PLAN REVIEW SHEET

Petition: 2014-092

Pavilion Development Company Email: bhorton@charlottenc.gov
Attachments: Bus Stop Standard 60.01C

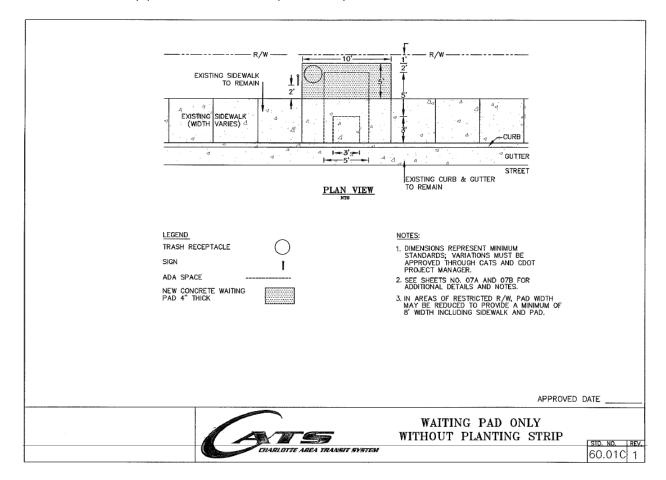
The Petitioner is requested to provide and construct a concrete waiting pad for a relocated bus stop along Tyvola Road. If retaining the existing sidewalk along the curb, the petitioner should use standard detail 60.01C. If new sidewalk is built away from the curb, or the proposed design changes, another standard detail may be more appropriate.

Below is an image of the standard detail (60.01C) for the requested bus stop pad. The site plan may either show the conceptual location of the improved bus stop on Tyvola Road, or alternatively, include a development note to locate the bus stop pad during the development review and permitting process.
